RE: REVISED DRAINAGE PLAN FOR DON KEITH MINI STORAGE (K11-D54) REVISION DATED 4/16/97

RE: REVISED ENGINEER CERTIFICATION FOR DON KEITH MINI STORAGE UNITS (K11-D54) REVISED CERTIFICATION STATEMENT DATED 9/22/98

DON KEITH MINI - STORAGE GRADING & DRAINAGE PLAN

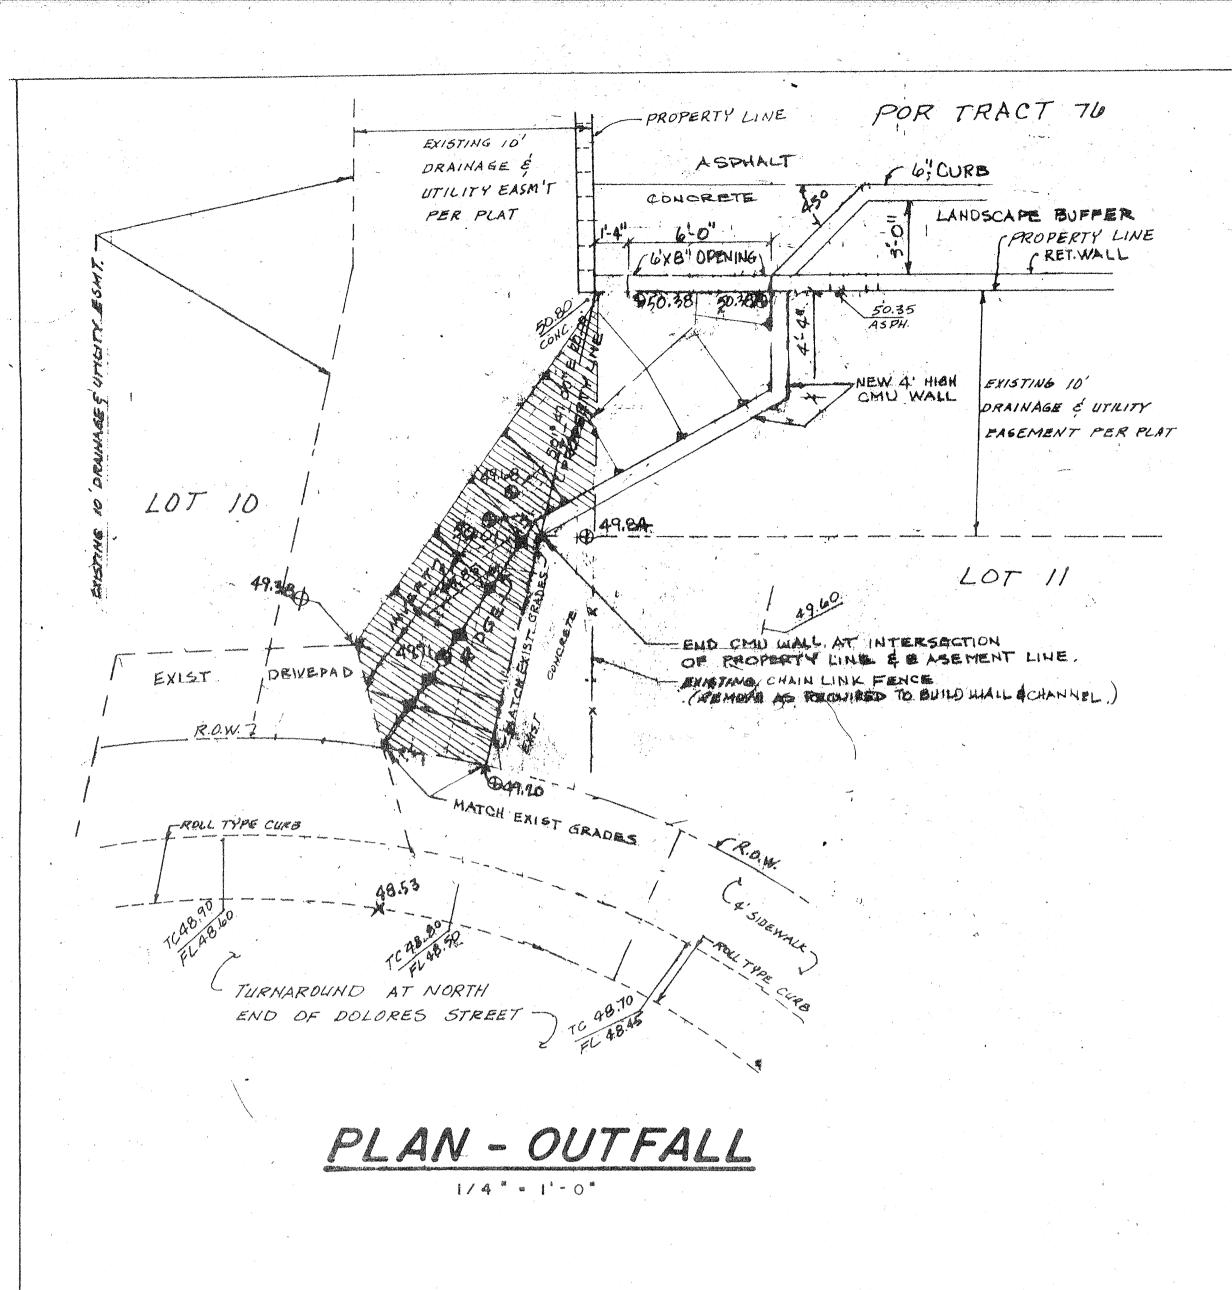
Based on the information provided on your April 22,1997 resubmittal, the above referenced site is approved for Building Permit. Please be advised that if the Building Permit has already been obtained, it is your responsibility to assure that the contractor is given a copy of this revised approved Drainage Plan.

Based on the information provided on your September 22,1998 resubmittal, Engineer Certification for the above referenced site is acceptable.
